# Access Compliance Report

## Public Rights-of-Way

### (Curb Ramps)

Intersection ID: 50585	Main Street: GRAND_FIR_RD	Cross Street: BENDING_BRANCH_RD	Location: SE
ADA ID: 2AD1B6C071C3	Ramp Type: Perp	Initial Pass/Fail: Fail	Overall Compliance: No
Codes/Mitigation Info/Possible Solution			Severity Score: 35
			Field Measurements/Component Compliance

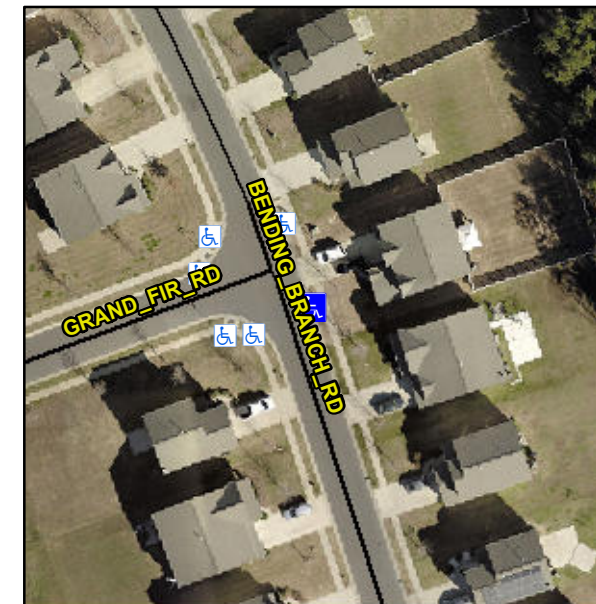
**Not Found, R304.5.1, R304.2.2, R304.5.3**

Compliance	Description	Data	Compliance	Description	Data
N/A	Ramp Length (in)	47.0	No	Ramp Slope (%)	14.8
No	Ramp Width (in)	47.5	No	Ramp XSlope (%)	3.5
N/A	Flare Type LT	N/A	N/A	Flare Type RT	N/A
N/A	Flare Slope LT (%)	N/A	N/A	Flare Slope RT (%)	N/A
N/A	Flare Traversable LT?	N/A	N/A	Flare Traversable RT?	N/A
N/A	Landing Length (in)	N/A	N/A	DWS Provided?	N/A
N/A	Landing Width (in)	N/A	N/A	DWS Contrast?	N/A
N/A	Landing Slope (%)	N/A	N/A	DWS Length (in)	N/A
N/A	Landing X Slope (%)	N/A	N/A	DWS Full Width?	N/A
N/A	Landing Curb? (Y/N)	N/A	N/A	DWS Offset (in)	N/A
N/A	Shared Landing?	N/A			
N/A	Gutter Ponding?	N/A	N/A	Gutter Slope (%)	N/A
N/A	Gutter Lip Ht (in)	N/A	N/A	Gutter X Slope (%)	N/A
N/A	Painted X Walk1?	No	N/A	Painted X Walk2?	N/A
	X Walk 1 Direction	To W		X Walk 2 Direction	N/A
N/A	X Walk 1 Width (in)	N/A	N/A	X Walk 2 Width (in)	N/A
	X Walk 1 Slope (%)	2.3		X Walk 2 Slope (%)	N/A
	X Walk 1 X Slope (%)	2.9		X Walk 2 X Slope (%)	N/A

**Remove & Replace Entire Ramp.**
